Service Bulletin

NO:HIFI2-01-006

SUBJECT: Intermittently Will Not Power ON

MODEL (S): MDS-JE440, MDS-JE640

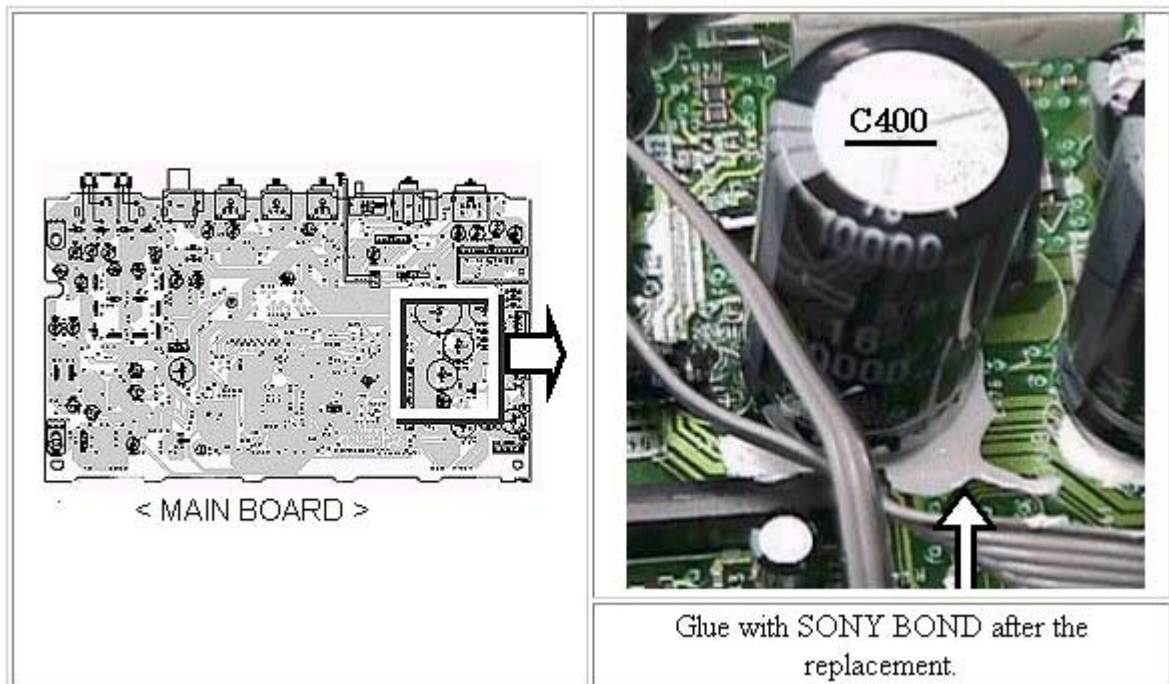
Symptom: Customer complaint states the unit intermittently will not power ON.

Solution: Replace the following component:

REF	FORMER		NEW	
	DESCRIPTION	PART NUMBER	DESCRIPTION	PART NUMBER
C400	3300UF/16V	1-126-936-51	10000UF/16V	1-126-939-11

1. Replace Ref# C400 CAPACITOR, 33000uF /16V, with CAPACITOR, 10000uF / 16V.
2. Secure the replacement CAPACITOR with SONY BOND (7-432-912-45).
